FPR
VOL 3

HISTORICAL VOLUME - LICENSING BASIS SUPPORT DOCUMENTATION

VOLUME 3 - APPENDIX R SECTIONS III.G, III.J, AND III.L CONFORMANCE

CABLE TRAY RISERS R379 AND R380

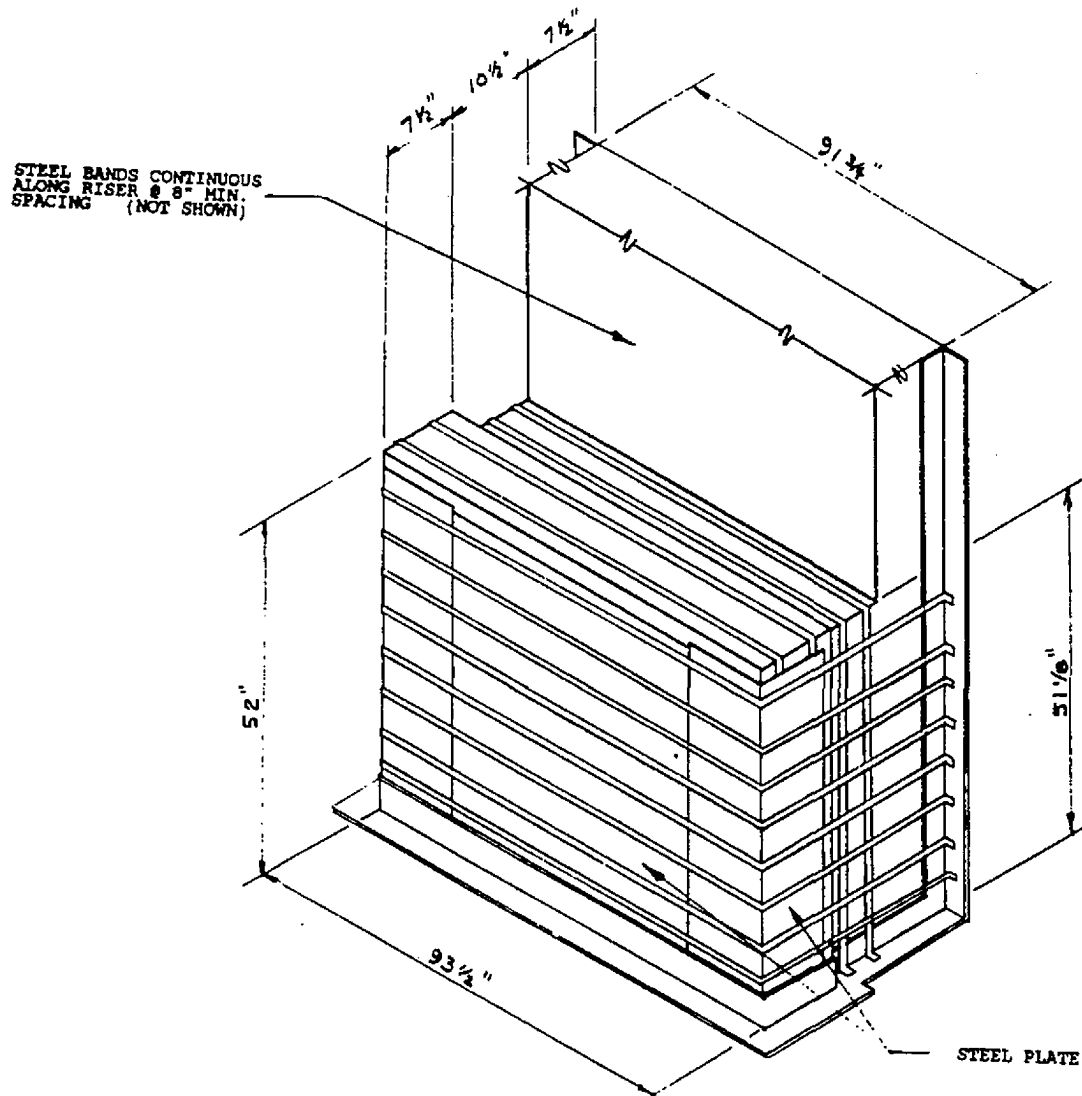
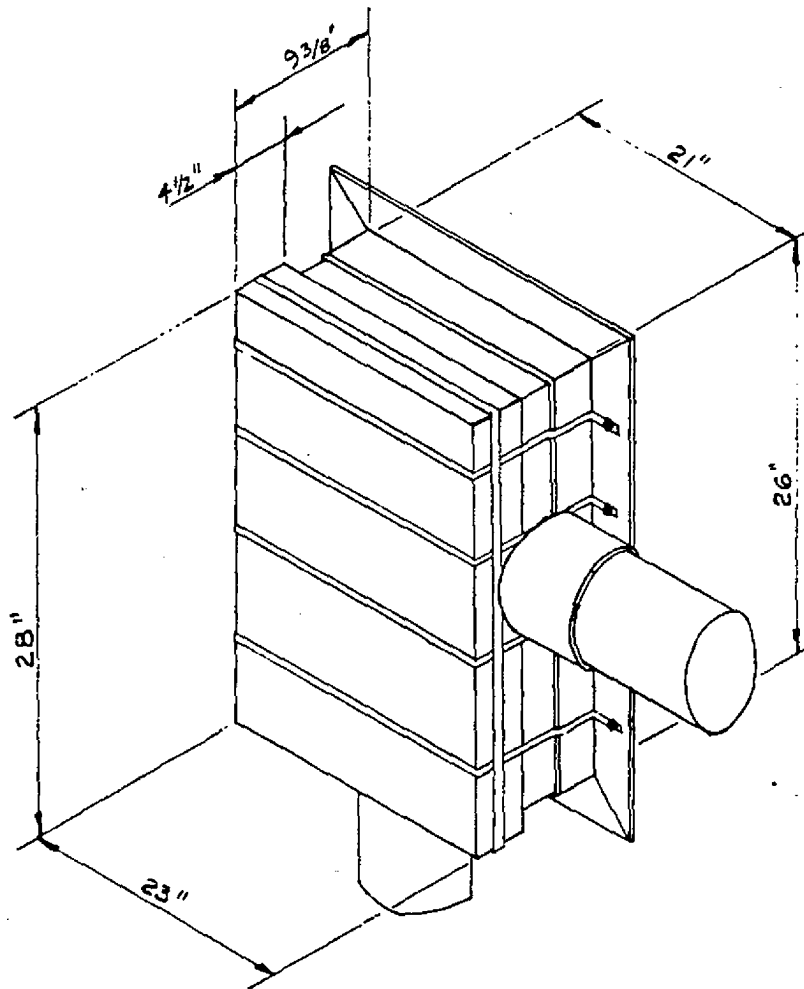
The licensee has fire wrapped risers on elevation 517' and 534' consisting of cable tray risers R379 and R380 which interconnect two large sheet metal pull boxes. Transco developed a fire wrap access cover to these pull boxes by using criteria from Transco Detail J6 and Special Drawing EJ 44 (dated January 30, 1987). Due to the numerous physical configurations that may be encountered in the field, 3M allows variances in its application of the material as long as it meets its design criteria. The observed access cover developed by Transco for the licensee appeared to meet the critical criteria such as number of layers, bands, caulking, etc., however, due to its unique design, it was requested that 3M review the installation of this design to ensure that its unique design had not invalidated its fire rating. This is considered an Open Item (237/88030-01(DRS); 249/88031-01(DRS)) pending review of the 3M response.

As part of the E-50 fire wrap systems installed at Dresden Station during 1987, several configurations were installed that did not follow a standard 3M detail. Deviations from details are permitted as according to 3M drawing 5300-QA, provided that critical design requirements are met. Several of the deviations included installation of removable covers on electrical junction boxes and pull boxes (see attachments). During the installation process, 3M representatives assisted the installers in proper installation procedures and techniques, though few standard detail drawings were formally prepared. The Nuclear Regulatory Commission (NRC), during a review of Dresden Station's 3M fire wrap installations, questioned the practice of installing non-standard designs without the development of special "site-specific" details. The NRC requested that CECO have the installed designs reviewed by 3M Corporation to ensure adherence to E-50 fire wrap system requirements. The attachments list the standard details which are believed to have been followed during the design and installation of the removable covers.
